E8364BH85-07A

S E R V I C E N O T E

E8364BH85 PNA Series RF Network Analyzers

Add-on mechanical components to enhance instrument reliability

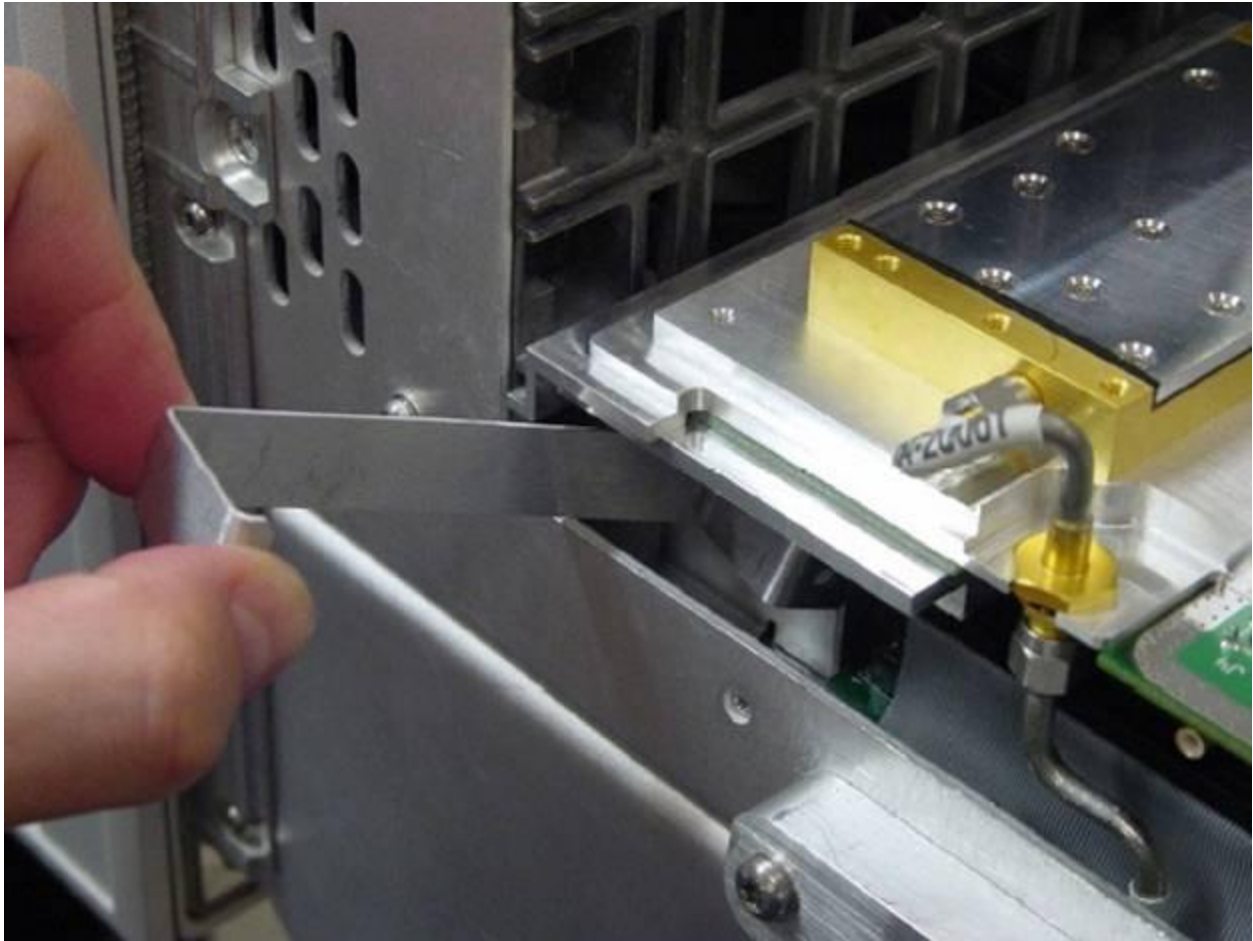
- a. Remove and discard existing screw near ribbon cable connector on System Motherboard. See below.

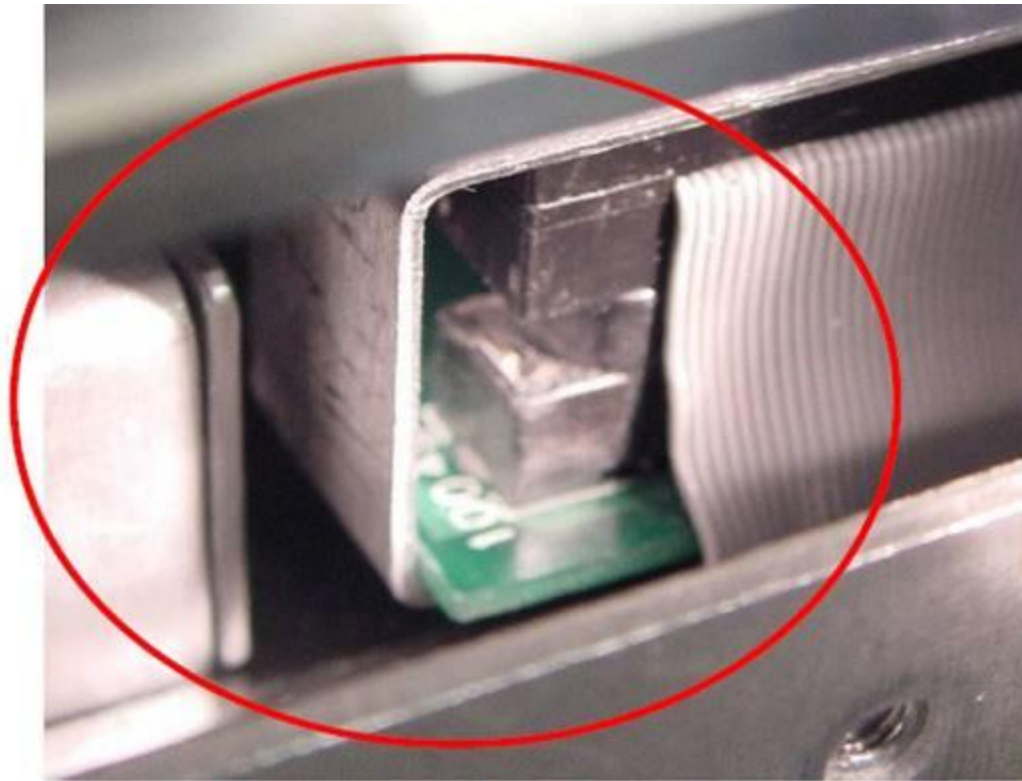
- b. Insert Ribbon Cable Clamp under Source Assembly as shown.

- c. Position the clamp over the Ribbon Connector. Use needle nose pliers if necessary to slide the clamp into place. Ensure that the edge of the clamp is parallel to the connector and not skewed.

NOTE: Ensure that the Clamp Lip is secured BELOW the edge of the System Motherboard

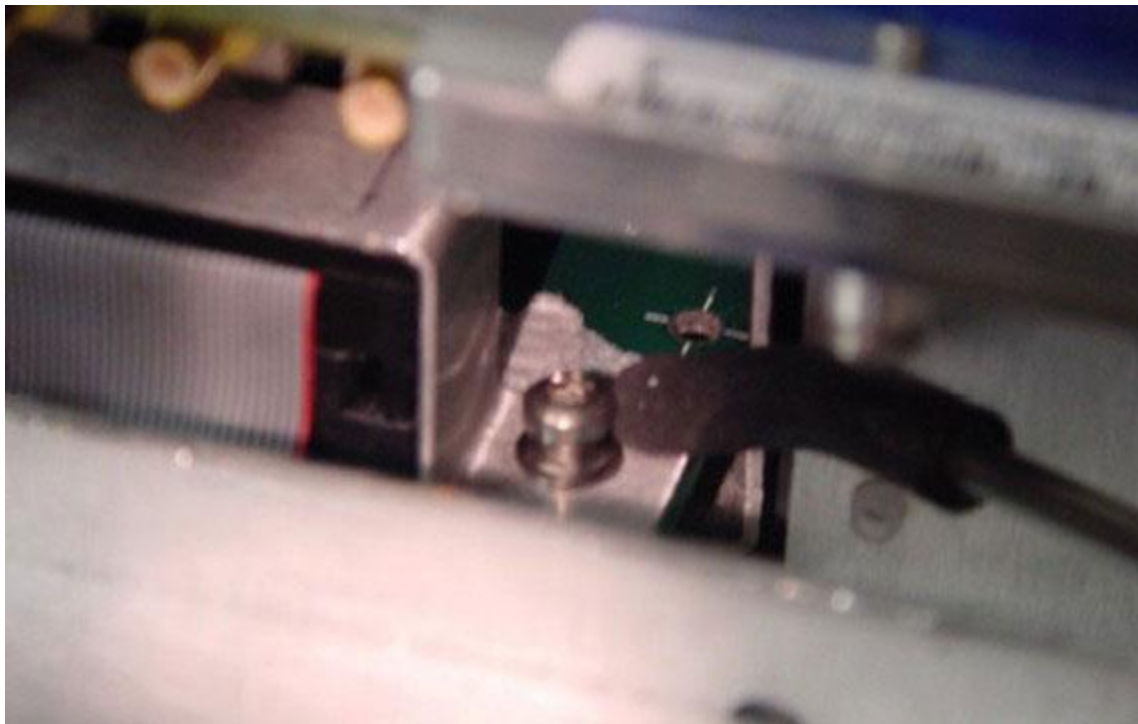
- d. Using tweezers, install a new 0515-0374 screw through the hole in the bracket.

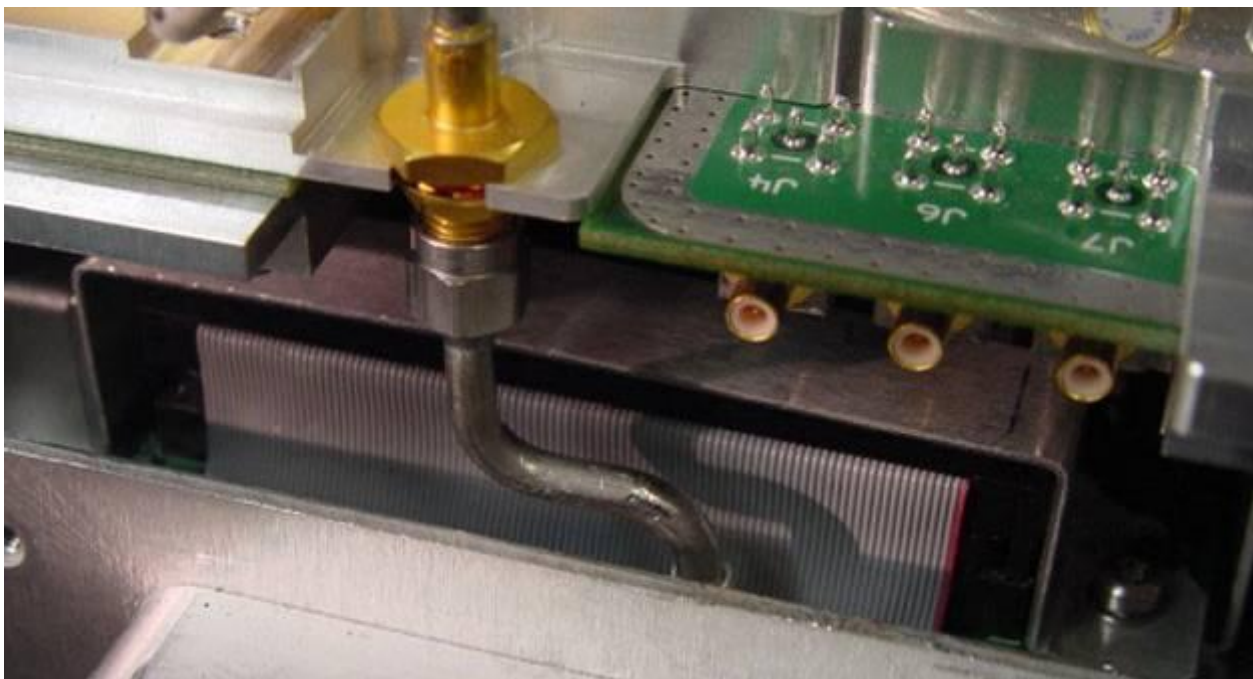
- f. Secure screw using the modified 10 lb-in breakaway wrench.

g. This image shows the final position of the secured clamp.

Figure 2a

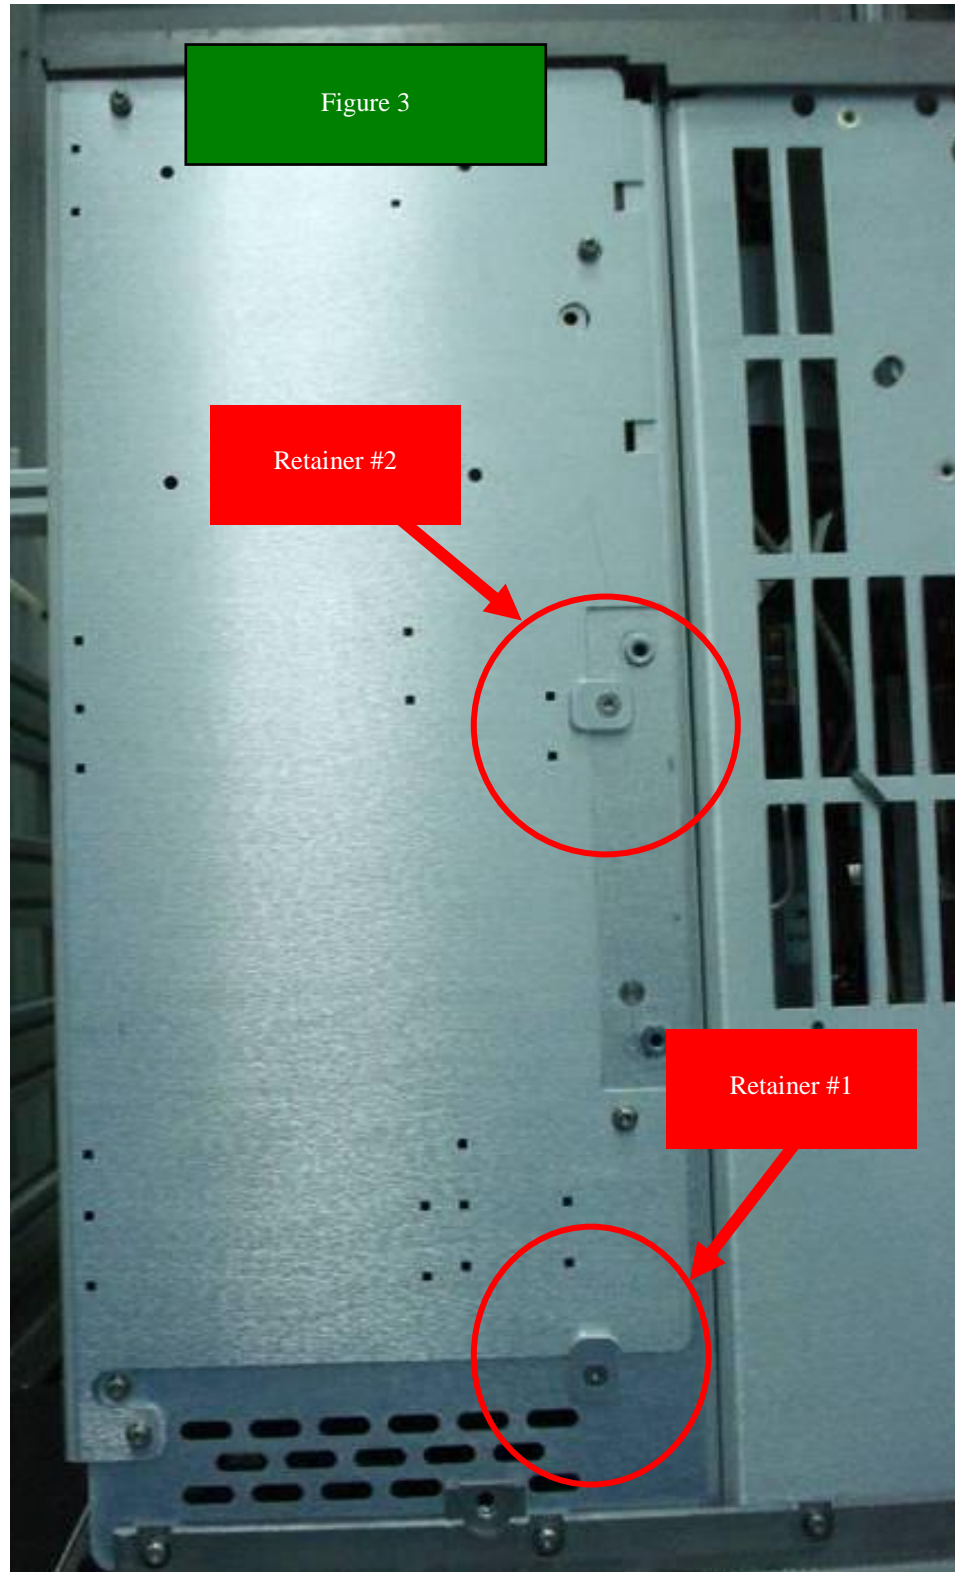
The Clip Retainer (E8361-20067) to be secured with Flat Head screw (0515-1644) in 2 places at 9 lb-in. This Retainer Clip may naturally rotate a bit when being secured, which is acceptable. Note that the existing screw needs to be removed and discarded prior installing Retainer Clip #1 (shown below in Figure 2a, 2b, and 3).
